Re: Annexation and Initial Zoning Parkdale-Masters

Re: Annexation and Initial Zoning Parkdale-Masters
AN-001140-2020 and IZ-001141-2020

To: Matt Janke – OEO, LLC
From: Audem Gonzales, Senior Planner
Date: April 24, 2020
Re: AN-001140-2020 Masters Property Annexation
IZ-001141-2020 Masters Property Initial Zoning
cc: Fred Starr, Chad Schroeder, John Prestwich

To: Audem Gonzales
From: Chad Schroeder, P.E., CFM, Development Engineer
Date: May 6, 2021
Subject: **Parkdale Masters Annexation**
CC: David Pasic
Wendi Palmer
Tyler Burhenn
Zachary Ahinga

URBAN DRAINAGE AND FLOOD CONTROL DISTRICT
AKA MILE HIGH FLOOD DISTRICT
MASTER PLAN DRAINAGEWAYS
TO COAL CREEK

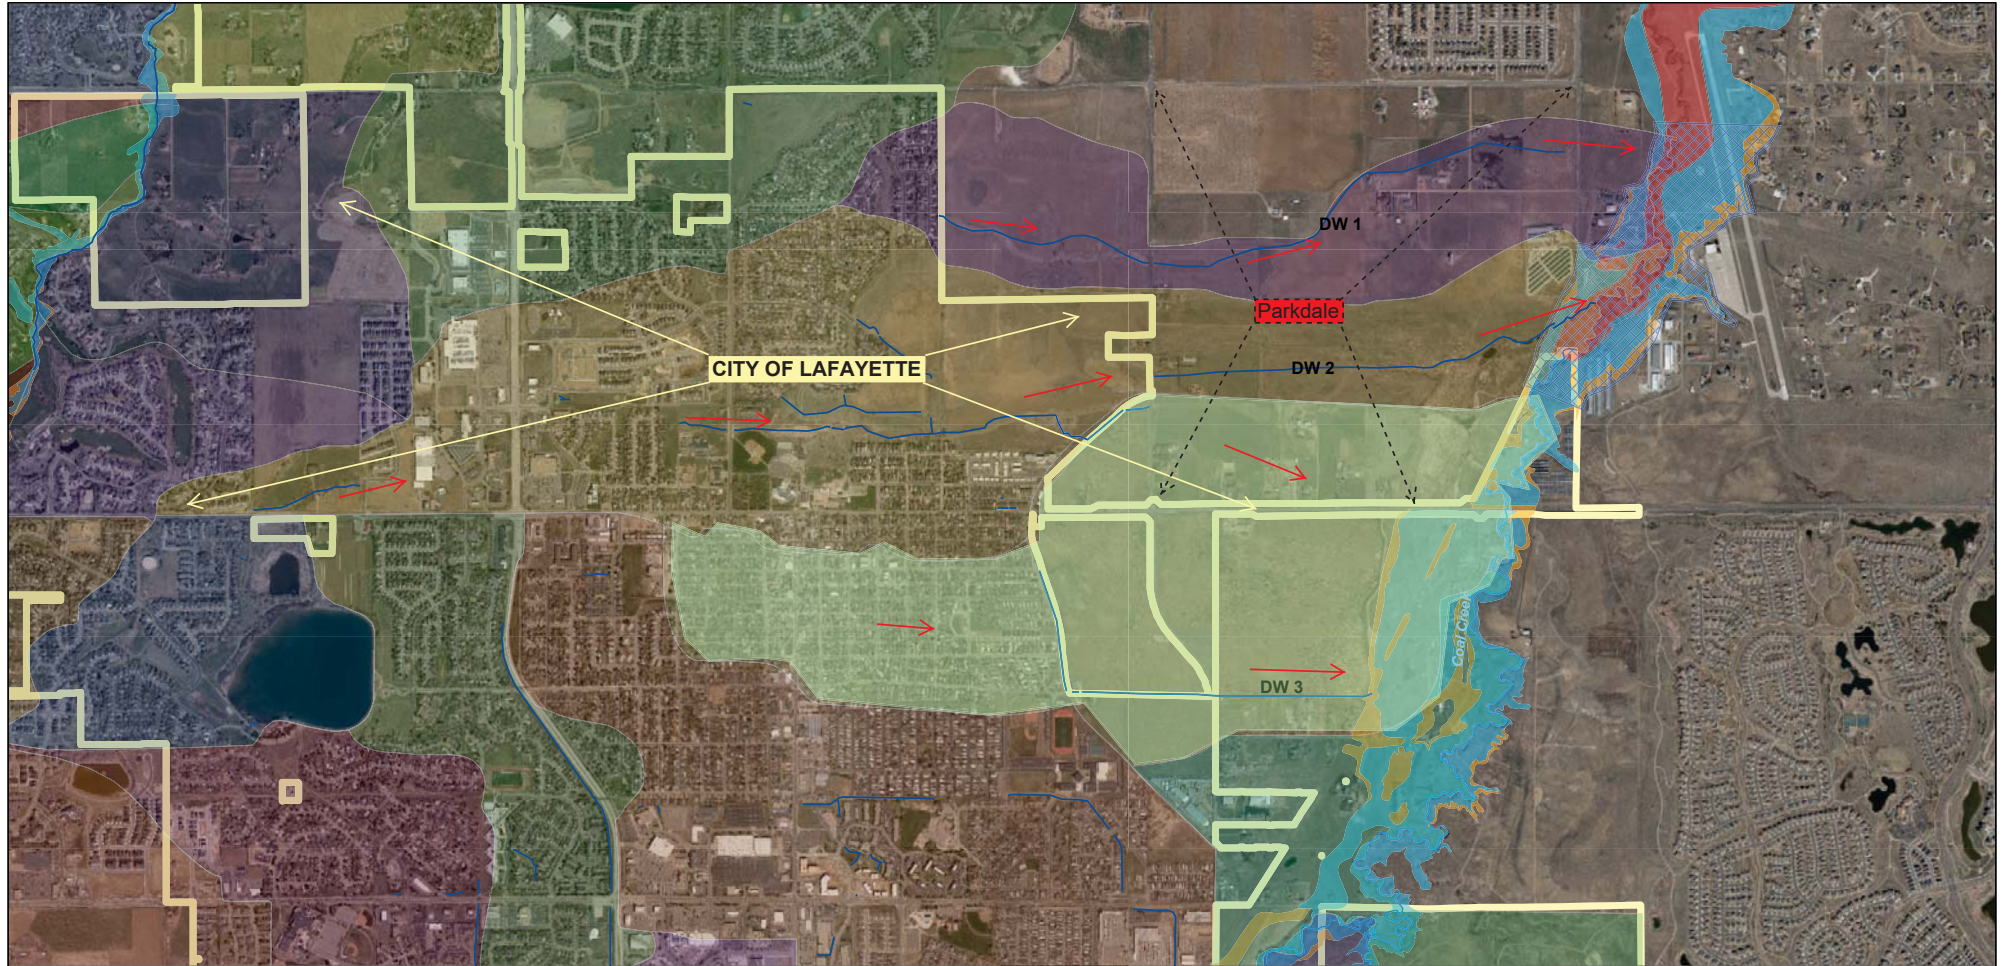
The Coal Creek UDFCD (MHFD) Master Plan designated historic tributary basins for Drainageway (DW) 1, 2 & 3 which partially overlap onto Parkdale. (See attached exhibit) DW 1 affects a west-east corridor in the northerly portion of Parkdale. DW 1 needs to be considered by Parkdale for right of way, installation, operations, and maintenance prior to, during and even after any development. DW 2 affects a significant west-east corridor through the central part of Parkdale, such drainageway also serving a larger tributary basin extending to 1 mile west of US 287. DW 2 needs to be considered by Parkdale for right of way, installation, operations, and maintenance prior to, during and even after any development. DW 3 does not appear to affect Parkdale, however a significant southerly portion of Parkdale is tributary to DW 3 and therefore Parkdale should be considered for participation in right of way, installation, operations, and maintenance prior to and during and even after any development.

ERIE GATEWAY SOUTH ANNEXATION NO. 8 ZONING MAP

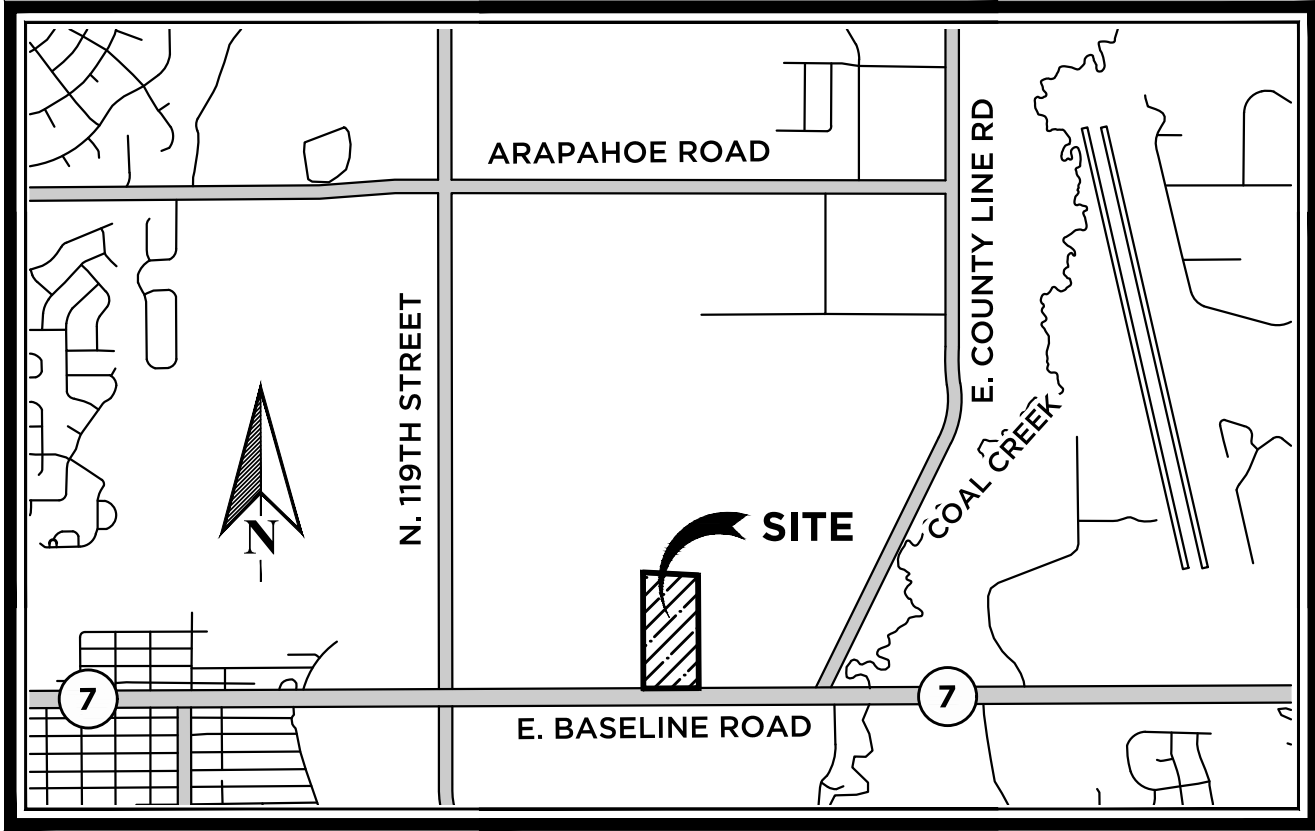
add Zoning Map to
the title

What is B.S.C?
Add to legend.

Add a note on the timing for the temporary uses. Something like "These temporary uses shall expire and no longer be permitted in this PD when the property develops with the principal uses listed in the Planning Area 1 table, etc etc." Propose language on when the temporary uses shall cease

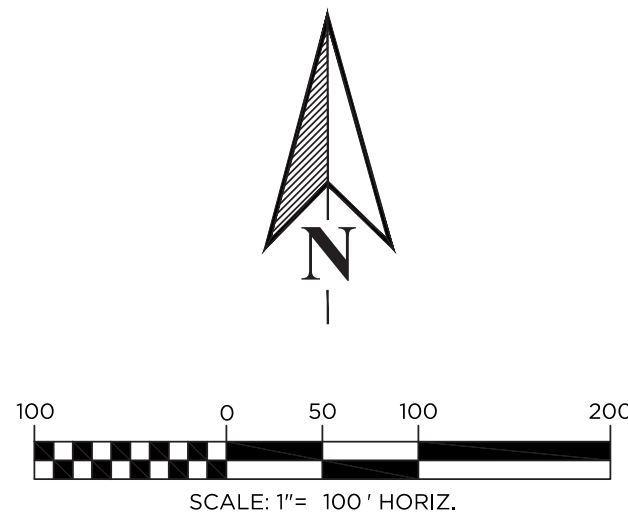
Not modifying MR standards. PD is a new zone district. The last sentence could stay but reference the MR standards.

This note can be deleted

Separate out Planning Area 1 Permitted Uses and a second Planning Area 1 Temporary Uses. Each can have a principal use column accessory use column. You can either list principal uses found in the UDC or state AGH principal and accessory uses shall apply under the temporary row. Accessory structure note can be removed and a simple N/A or not permitted can be listed under accessory column. Also, Single Family Alley Load, should that be Townhome? SFD will not be allowed in this filing. The housing diversity is already missing a third housing product with Penner Thero. The Town expressed concern with this before and is looking for a new product type on Masters.

COVER
SHEET

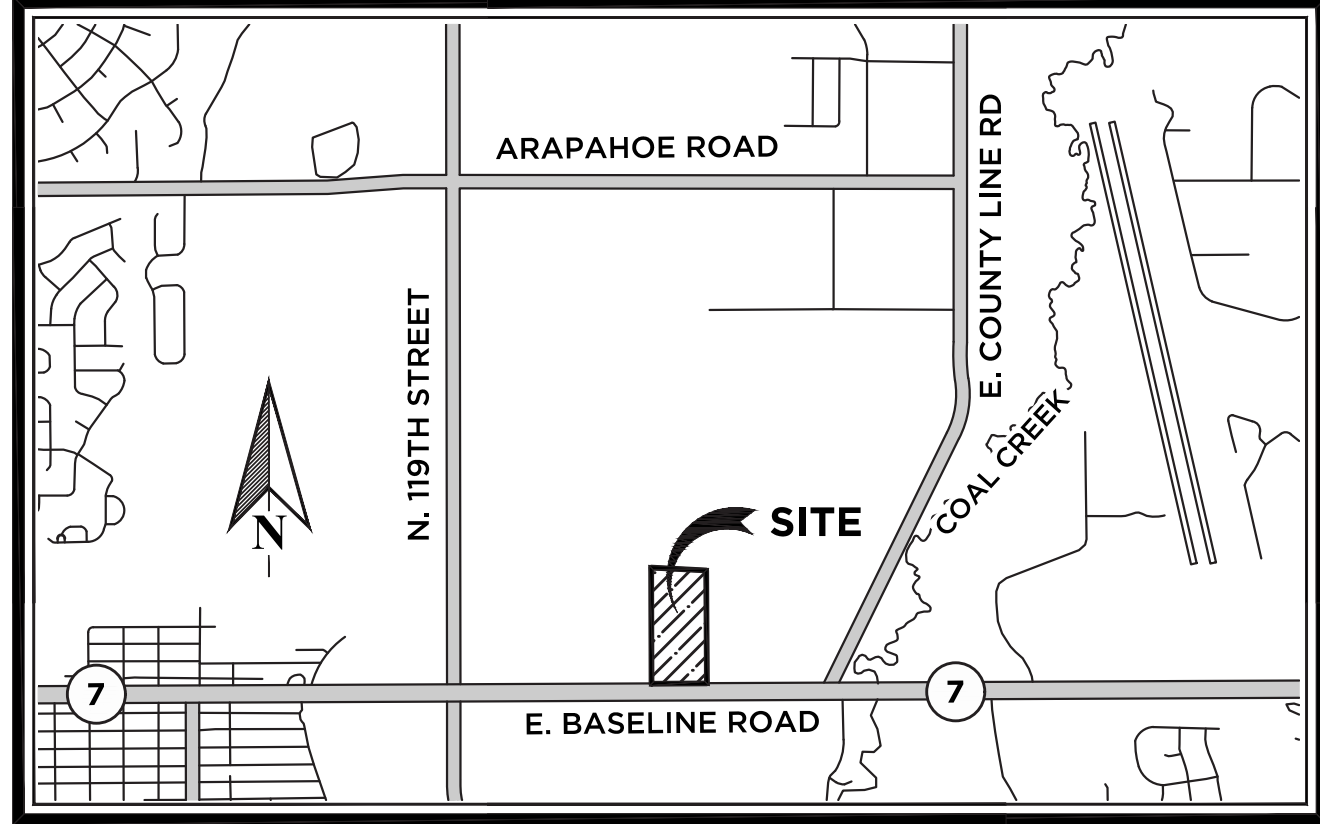
Use same IZ project
number as before

Remove Acc. Already
listed in table of uses
as not permitted
